Summary of SAB findings for Question #3

Perspective 4

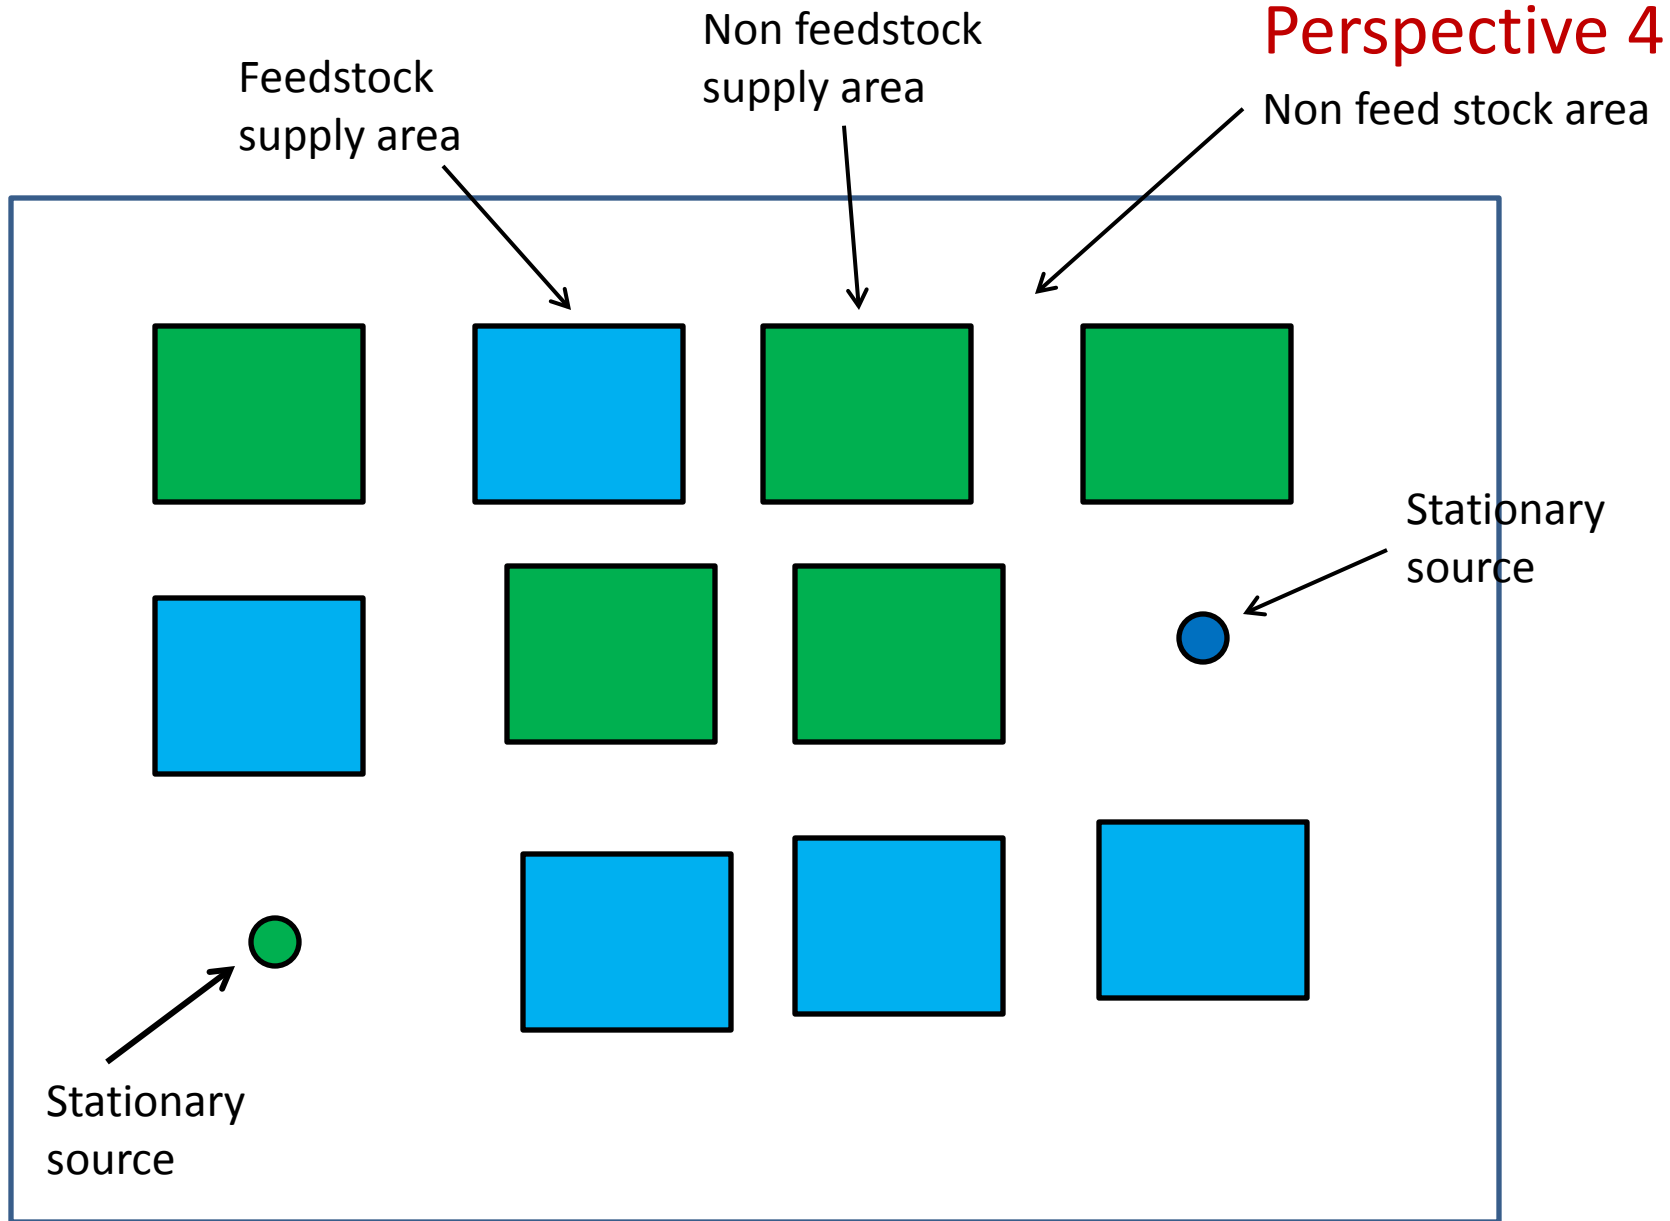
Restructuring of the framework equation and clarification of concepts and terminology

Use of equation must be scale robust.

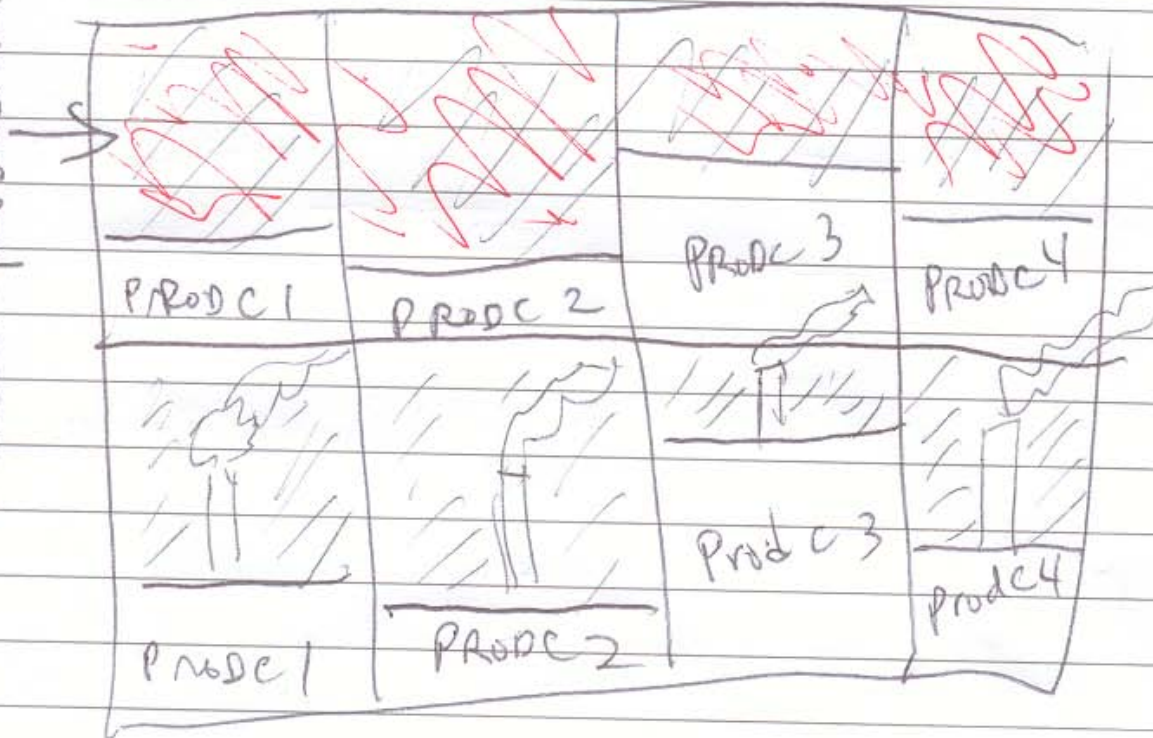
LAR remains the same
regardless of sequence
